ADDENDUM NO. 1 to the MITIGATED NEGATIVE DECLARATION for JURUPA COMMUNITY SERVICES DISTRICT RECYCLED WATER EXPANSION (DISTRICT PROJECT NO. C133656)

Description and Setting of the Revised Project

Figure 2 - Revised Project

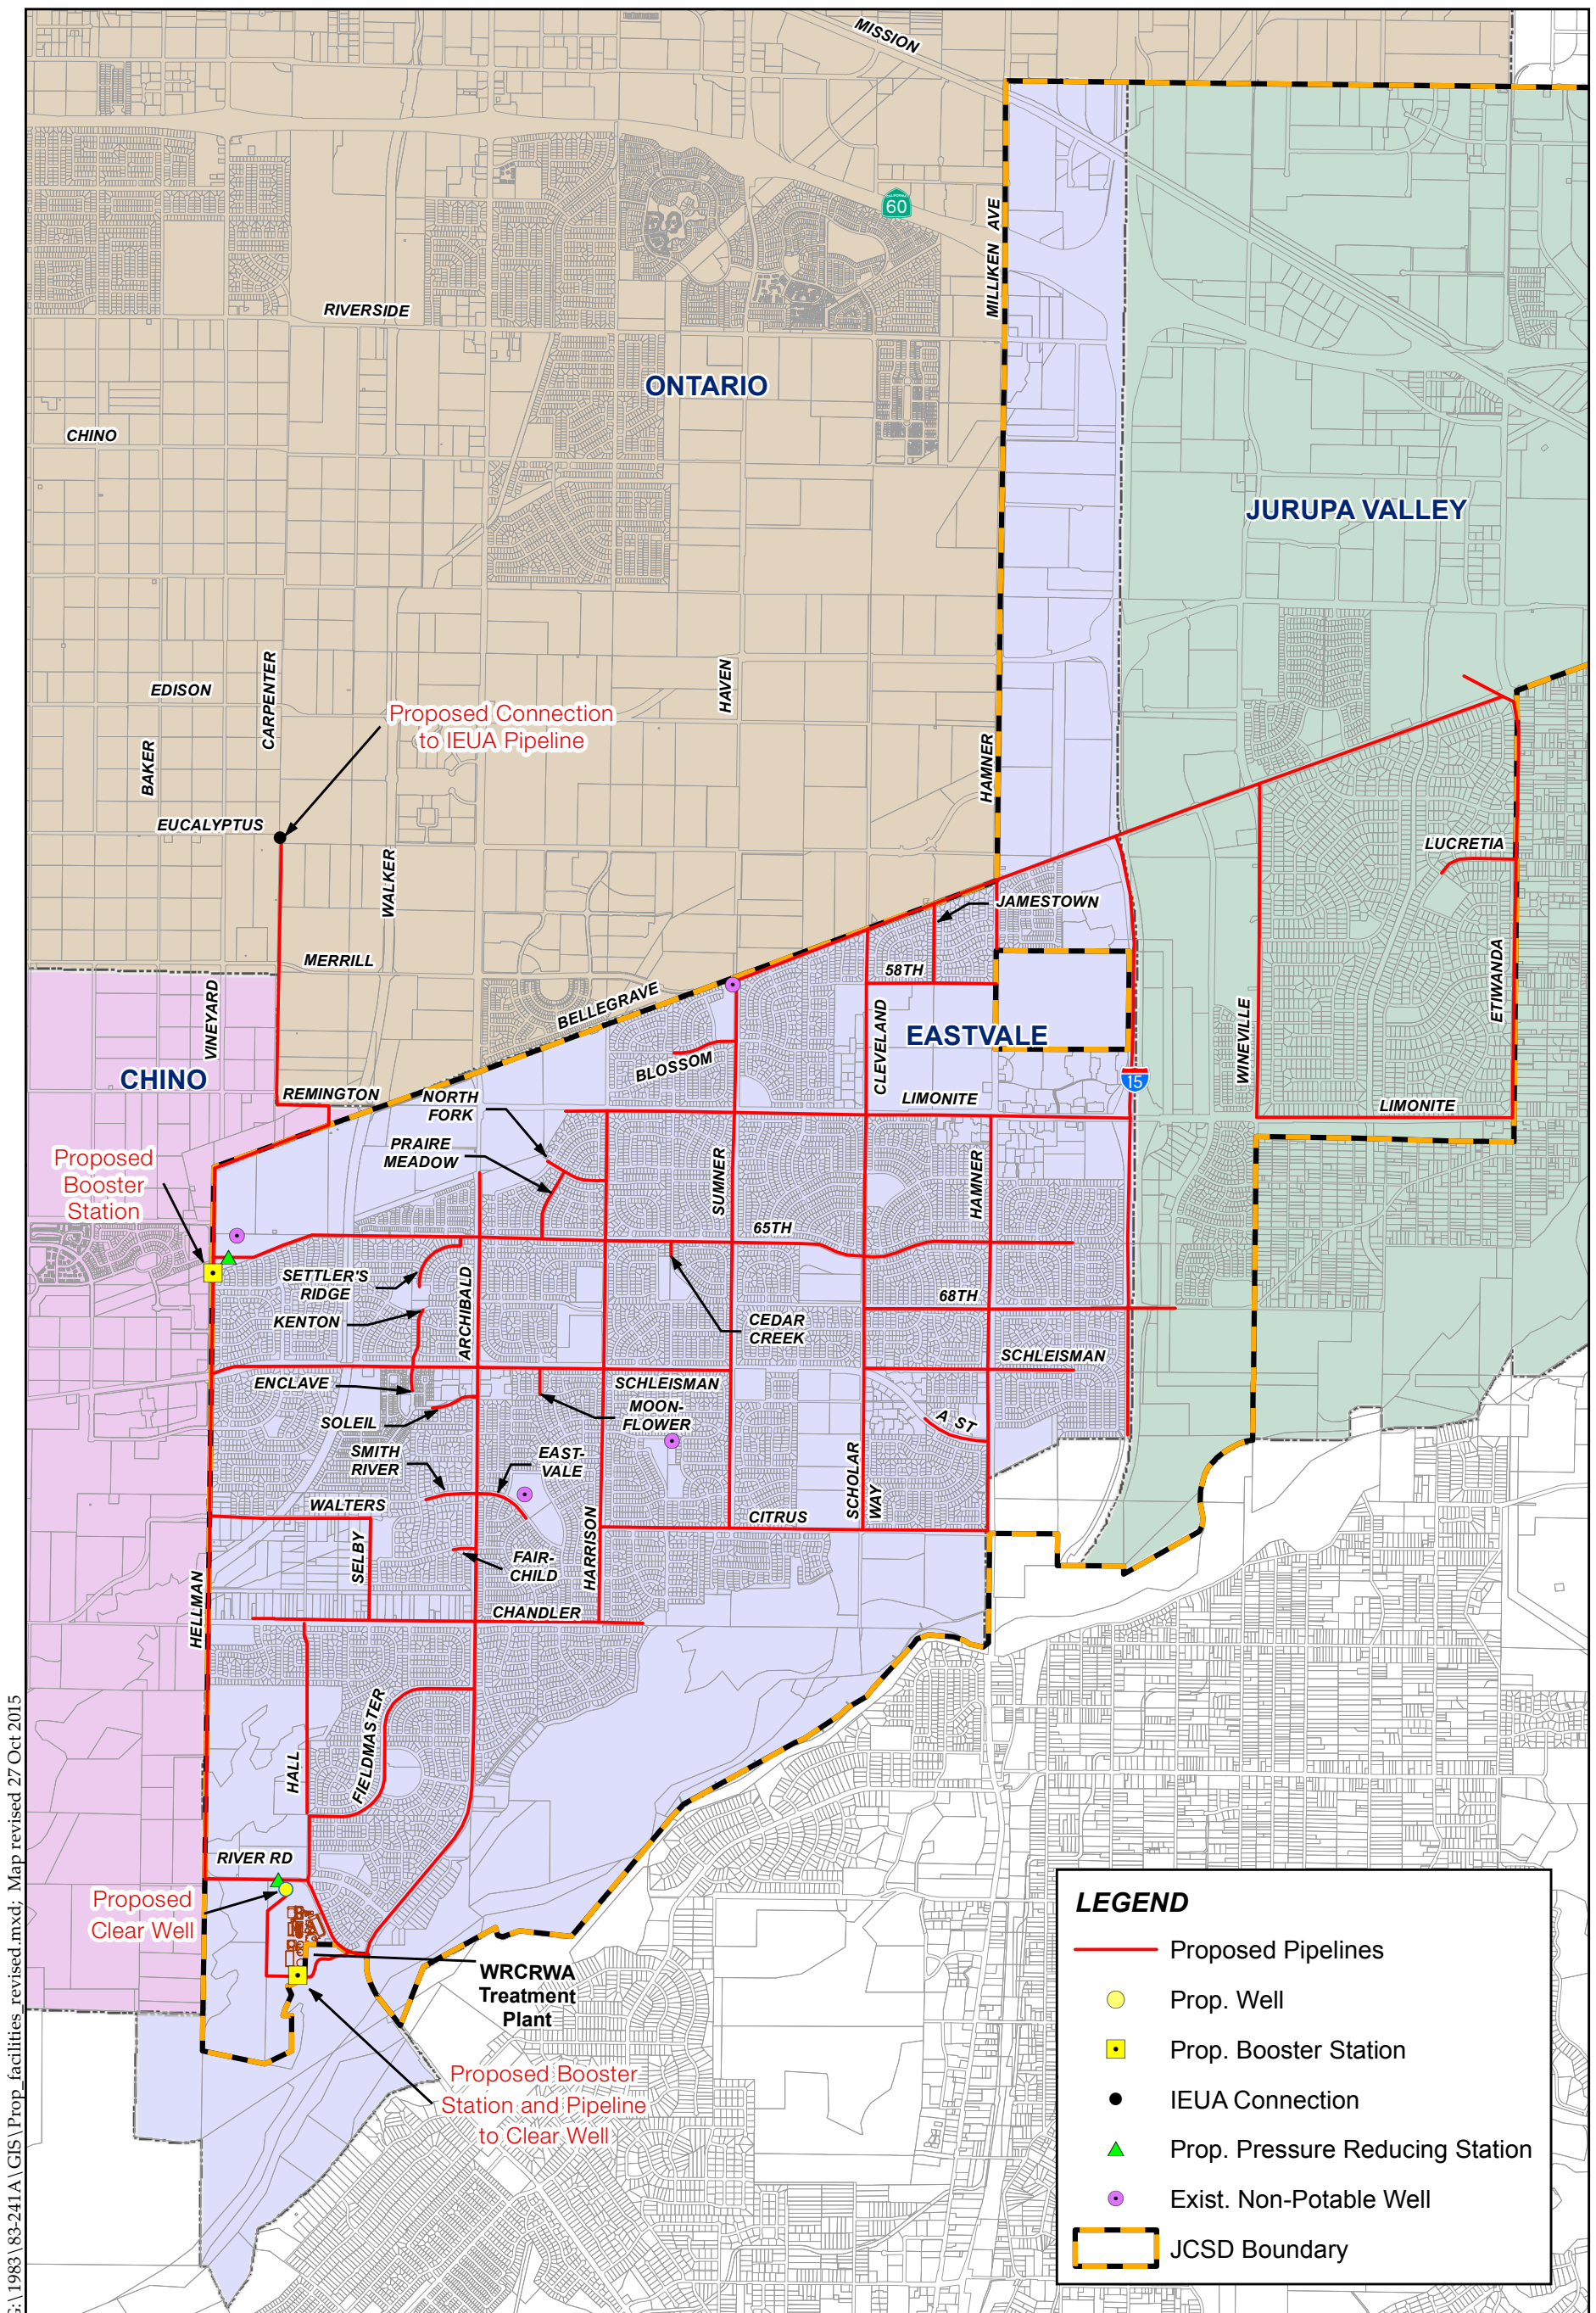
In the 2015 MND the Original Project included a proposed recycled water pump station and water reservoir which were to be located at either one of two sites in the City of Ontario (referred to as Survey Area 1 and Survey Area 2). At either of these sites, up to three acres of Prime Farmland were to be converted to non-agricultural use. The Revised Project proposes a new location for the pump station, which would not require construction of a reservoir or construction of the water pipeline along Carpenter Street, from Eucalyptus Avenue to Schaefer Avenue. The Revised Project proposes construction of the pump station in an established park, the American Heroes Park, located in the City of Eastvale as shown in **Figure 2 – Revised Project**. No other revisions to the Project as evaluated in the 2015 MND are proposed. Surrounding land uses include residential and agriculture. Further, the mitigation measures identified in the 2015 MND with minor clarifications are adequate to mitigate for any potentially significant impacts associated with the Revised Project. The minor revisions that are needed for the mitigation measures to be applicable to the Revised Project are shown in strikethrough (~~strikethrough~~) and underline (underline) text. None of the revisions to the mitigation measures change the intent or outcome, they mere clarify changes in location of the facilities.

The 2015 MND found that implementation of the Original Project would not contribute to the deterioration of any park or recreational facility. The Revised Project proposes construction of a booster station in the American Heroes Park in Eastvale. Because the booster station will have a small footprint, be located along the park edges away from the active use park areas, and will not require frequent maintenance; impacts will still be less than significant.
